REVISIONS		
NUMBER	DATE	DESCRIPTION
⚠	06/04/2010	ADDED PUMP STATIONS GENERAL NOTES 5 AND 6.

LOW PRESSURE DETAILS

ANIMAL SCIENCE RESEARCH CENTER
SANITARY SEPARATION PHASE II - 2010

SHEET NO.
C-500

DOSING PUMP STATION
NOT TO SCALE

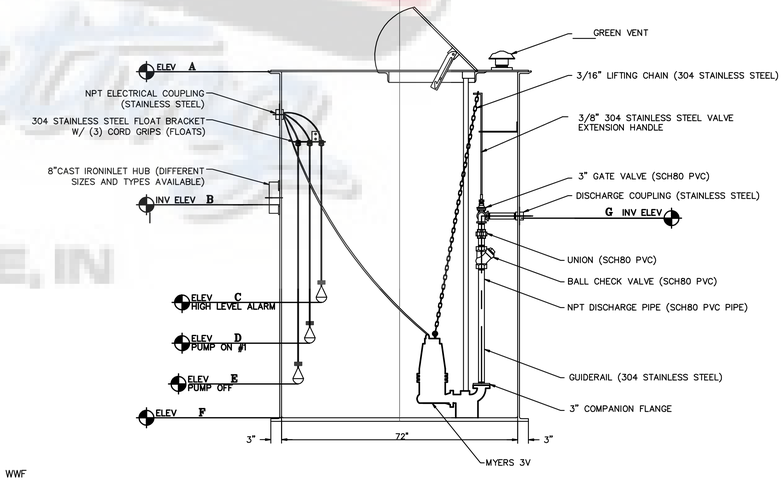
⚠
5. MOUND DOSING PUMP STATION SHALL BE CONSTRUCTED WITH 1 PUMP AND ALL STATION PIPING REQUIRED FOR 3 PUMPS AS PART OF THE BASE BID. IF ALTERNATES 1 AND/OR 4 ARE CHOSEN, ADDITIONAL PUMPS SHALL BE INSTALLED IN THE STATION. STATION PIPING WITHOUT A PUMP OR FORCE MAIN ATTACHED SHALL BE CAPPED ON BOTH ENDS.
6. THE MOUND DOSING PUMP STATION CONTROL PANEL SHALL BE SET UP SUCH THAT, DEPENDING ON WHICH ALTENATE(S) ARE CHOSEN, THE STATION CAN CONTROL 1 PUMP, ALTERNATE 2 PUMPS, OR ALTERNATE 3 PUMPS.

GENERAL LOCATION PLAN AND BID ITEM MAP

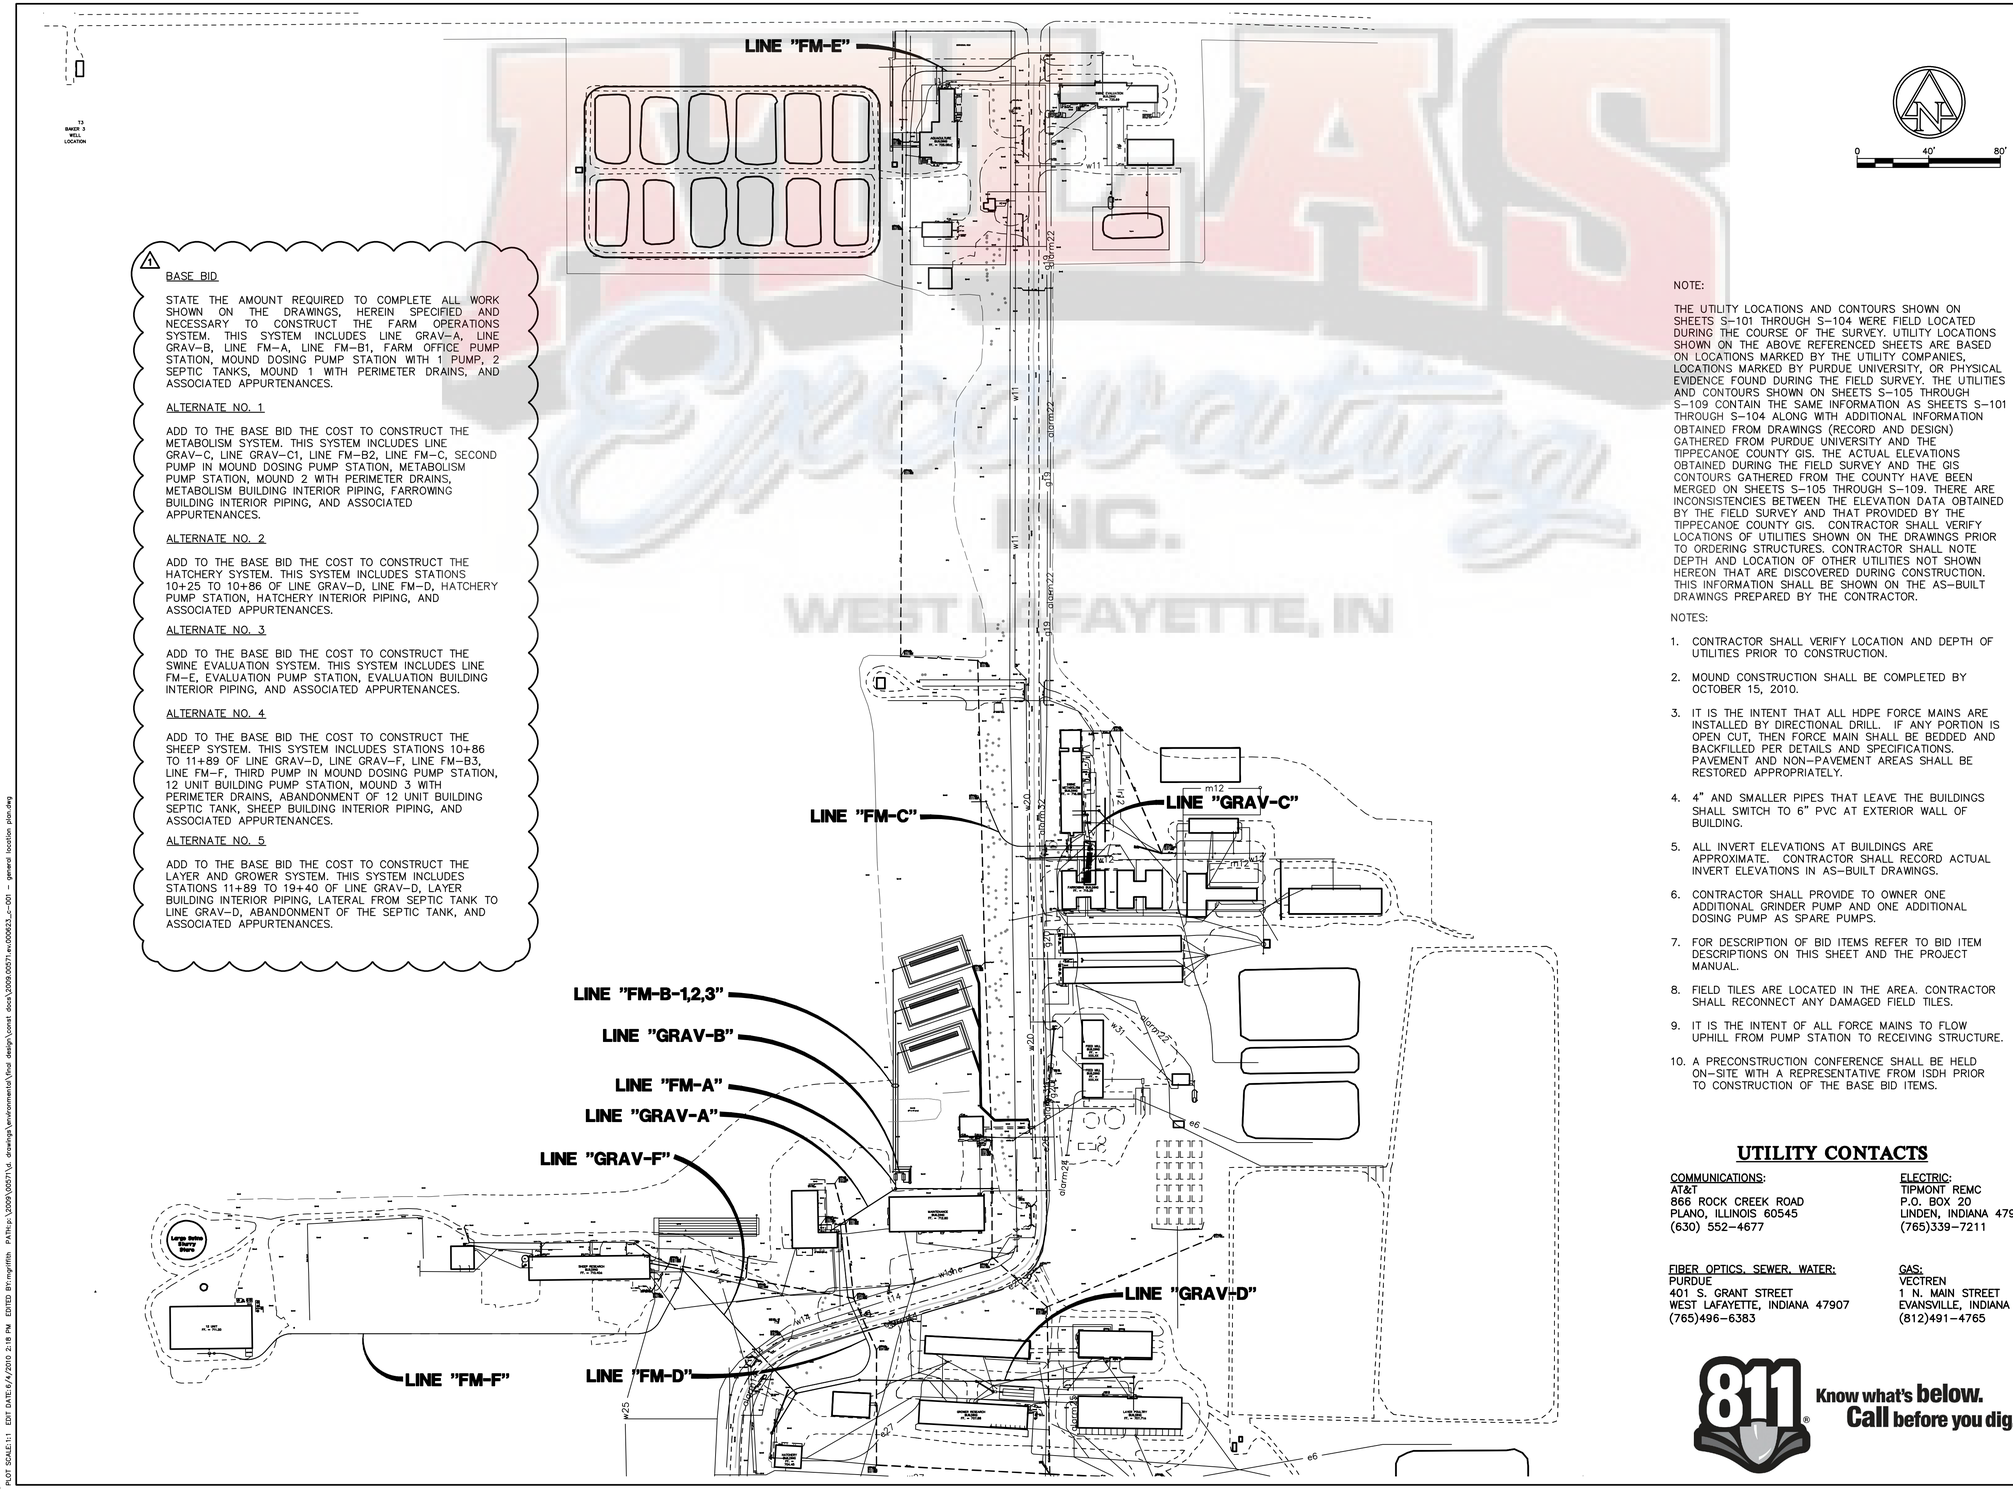
REVISIONS		
NUMBER	DATE	DESCRIPTION
1	06/04/2010	UPDATED BASE BID AND ALTERNATE NOTES.

STATE THE AMOUNT REQUIRED TO COMPLETE ALL WORK SHOWN ON THE DRAWINGS, HEREIN SPECIFIED AND NECESSARY TO CONSTRUCT THE FARM OPERATIONS SYSTEM. THIS SYSTEM INCLUDES LINE GRAV-A, LINE GRAV-B, LINE FM-A, LINE FM-B1, FARM OFFICE PUMP STATION, MOUND DOSING PUMP STATION WITH 1 PUMP, 2 SEPTIC TANKS, MOUND 1 WITH PERIMETER DRAINS, AND ASSOCIATED APPURTENANCES.

ADD TO THE BASE BID THE COST TO CONSTRUCT THE METABOLISM SYSTEM. THIS SYSTEM INCLUDES LINE GRAV-C, LINE GRAV-C1, LINE FM-B2, LINE FM-C, SECOND PUMP IN MOUND DOSING PUMP STATION, METABOLISM PUMP STATION, MOUND 2 WITH PERIMETER DRAINS, METABOLISM BUILDING INTERIOR PIPING, FARROWING BUILDING INTERIOR PIPING, AND ASSOCIATED APPURTENANCES.

ADD TO THE BASE BID THE COST TO CONSTRUCT THE HATCHERY SYSTEM. THIS SYSTEM INCLUDES STATIONS 10+25 TO 10+86 OF LINE GRAV-D, LINE FM-D, HATCHERY PUMP STATION, HATCHERY INTERIOR PIPING, AND ASSOCIATED APPURTENANCES.

ADD TO THE BASE BID THE COST TO CONSTRUCT THE SWINE EVALUATION SYSTEM. THIS SYSTEM INCLUDES LINE FM-E, EVALUATION PUMP STATION, EVALUATION BUILDING INTERIOR PIPING, AND ASSOCIATED APPURTENANCES.

ADD TO THE BASE BID THE COST TO CONSTRUCT THE SHEEP SYSTEM. THIS SYSTEM INCLUDES STATIONS 10+86 TO 11+89 OF LINE GRAV-D, LINE GRAV-F, LINE FM-B3, LINE FM-F, THIRD PUMP IN MOUND DOSING PUMP STATION, 12 UNIT BUILDING PUMP STATION, MOUND 3 WITH PERIMETER DRAINS, ABANDONMENT OF 12 UNIT BUILDING SEPTIC TANK, SHEEP BUILDING INTERIOR PIPING, AND ASSOCIATED APPURTENANCES.

ADD TO THE BASE BID THE COST TO CONSTRUCT THE LAYER AND GROWER SYSTEM. THIS SYSTEM INCLUDES STATIONS 11+89 TO 19+40 OF LINE GRAV-D, LAYER BUILDING INTERIOR PIPING, LATERAL FROM SEPTIC TANK TO LINE GRAV-D, ABANDONMENT OF THE SEPTIC TANK, AND ASSOCIATED APPURTENANCES.
